APPLICATION FOR A CERTIFICATE OF APPROPRIATENESS – STAFF REPORT

COA-0029-2019308 LINDEN AVENUEApplicant:DAMIAN O'FARRILLReceived:3/12/19Submission date + 90 days:6/10/191) 4/25/

<u>Historic District</u>: OAKWOOD HISTORIC DISTRICT <u>Zoning</u>: General HOD <u>Nature of Project</u>: Construct screened porch; paint house new colors; changes to doors and windows

A2 SITE PLAN

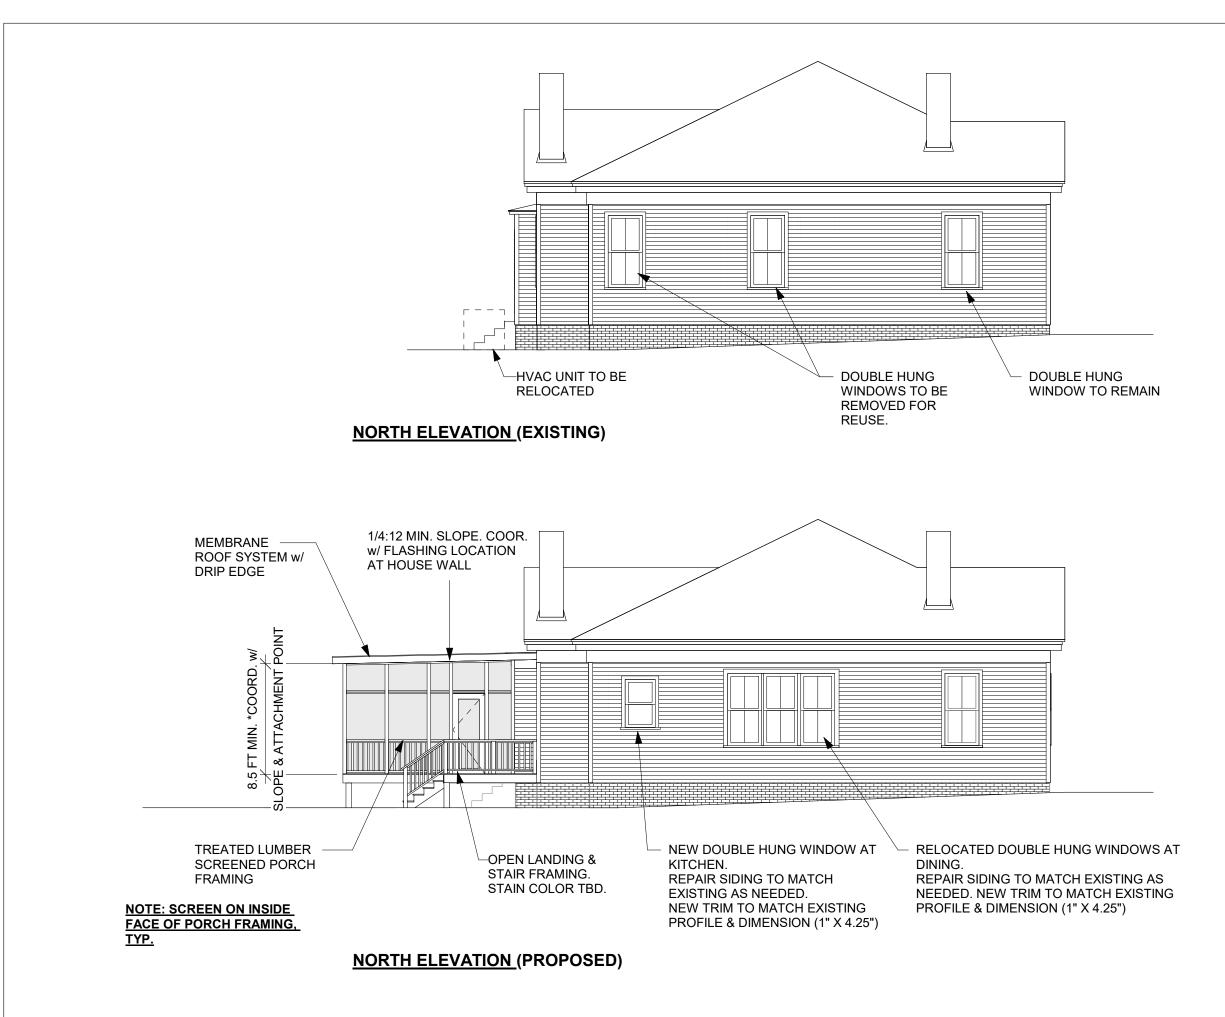
- 2* The application proposes construction of a screened porch at the rear of the existing house.A small portion of pavers is proposed to be removed.

- 14* A tree protection plan was provided which was prepared by an ISA-certified arborist. However, no tree protection fencing was shown nor was any protective laydown material provided along the side property lines where the trees and tree roots are found. The tree protection plan specified that footings are to be hand dug.

- 15* The drawings show the existing HVAC equipment will be relocated from the east side of the house to the south side. Screening plantings are shown, but no species information was provided.

- 1. That tree protection plans be implemented and remain in place for the duration of construction.
- 2. That only the lower sash of the rearmost window on the north façade be removed.
- 3. That trim on the historic house be wood.

- a. An updated tree protection plan showing tree protection fencing or appropriate alternatives to protect trees and tree roots during construction;
 - b. Manufacturer's specifications for windows, showing both section and elevation views, muntin profiles and material descriptions.

A3 NORTH ELEVATION

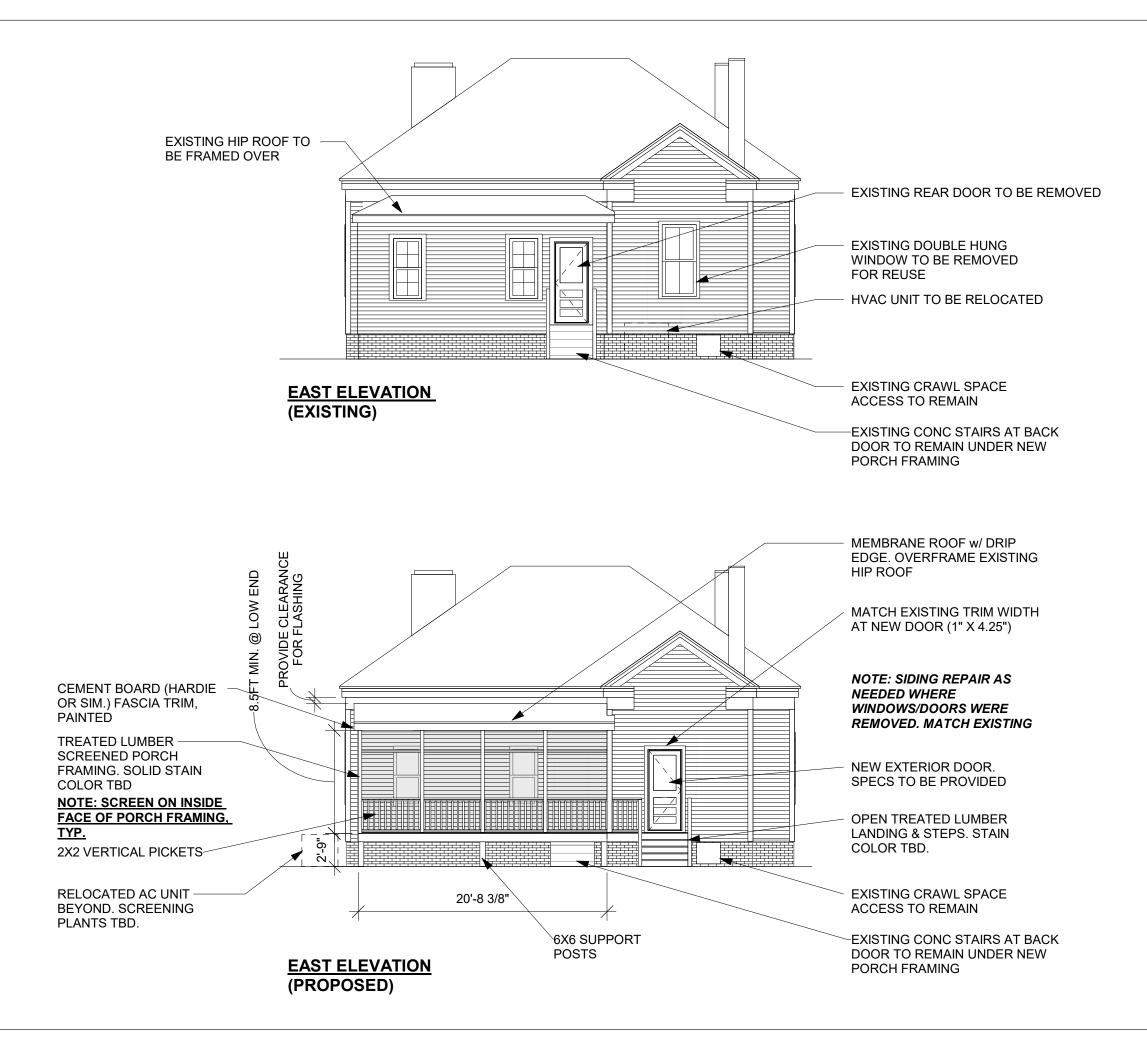
- Removing the double-hung window on the north façade toward the rear of the house and replacing it with a smaller double-hung window that is moved slightly forward on that side;

- c. Removing the double-hung window on the north façade in the center of the wall and installing all three windows proposed for removal in an enlarged opening on that same wall.

- 10* Removing an existing window and replacing it with a smaller unit as described above has rarely been approved for a side façade in the historic district. However, the removal of the

lower sash of windows similarly located (side façade at the rear) has been approved and is routinely approved as a Minor Work by staff.

- 11* A determination of whether the north façade is character-defining has not been made.
- 12* A note indicates the trim on the new door and windows will match the width and profile of the existing; however, the material was not specified. On historic houses, wood is the only trim material found to meet the *Design Guidelines*.

A6 WEST ELEVATION & SCREEN DTL

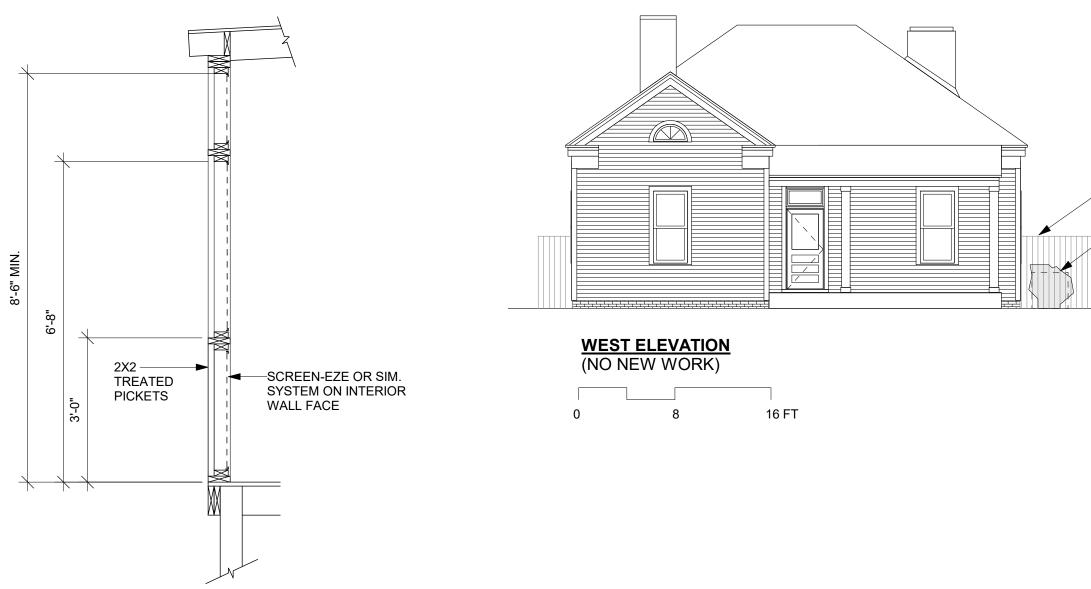
- 6* The proposed porch is to be framed with treated lumber and stained. No stain color samples were provided.
- 7* According to the application text, the screening for the porch is to be on the inside of the porch framing. A section drawing of the screened porch was provided; however, a detailed drawing of the railing was not.

- b. Stain color swatches from the paint/stain manufacturer for the porch structure;
 - c. Deck railing, both elevation and section details;
 - d. HVAC screening plant species;

A9 **NEIGHBORHOOD MASSING DIAGRAM**

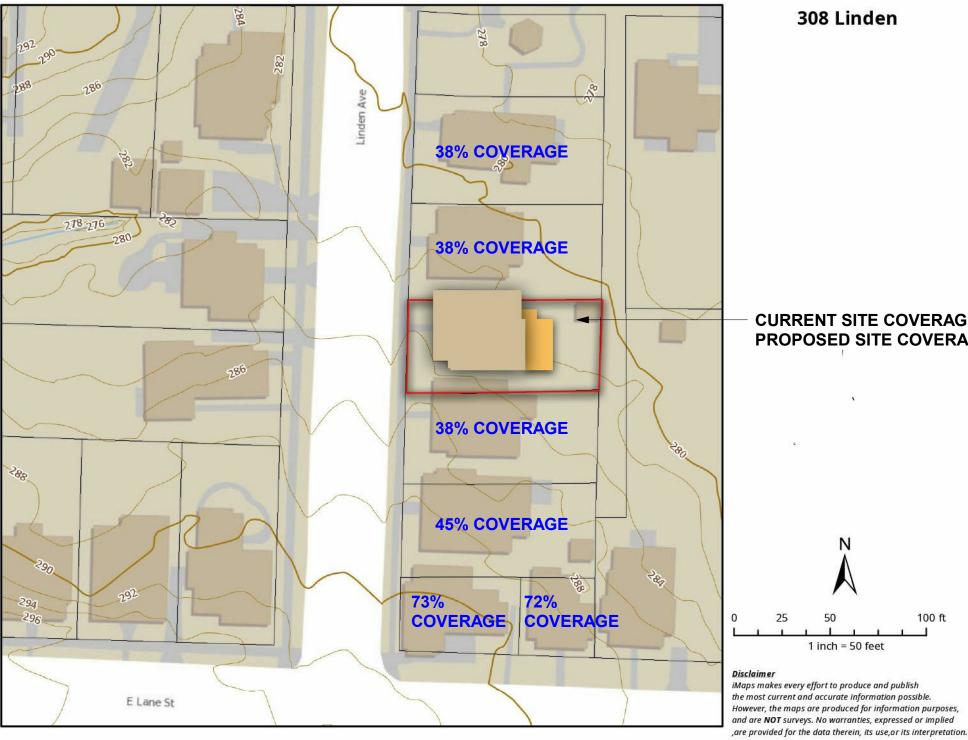
- 4* Built mass to open space analysis: According to iMaps, the lot totals 4,792 SF (0.11 acres) with a heated area of 1,348 SF. The applicant provided a diagram showing the "site coverage" of the applicants' property as 39.9% currently and 48% proposed. Neighboring properties' site coverage ranges from 38% to 73%.
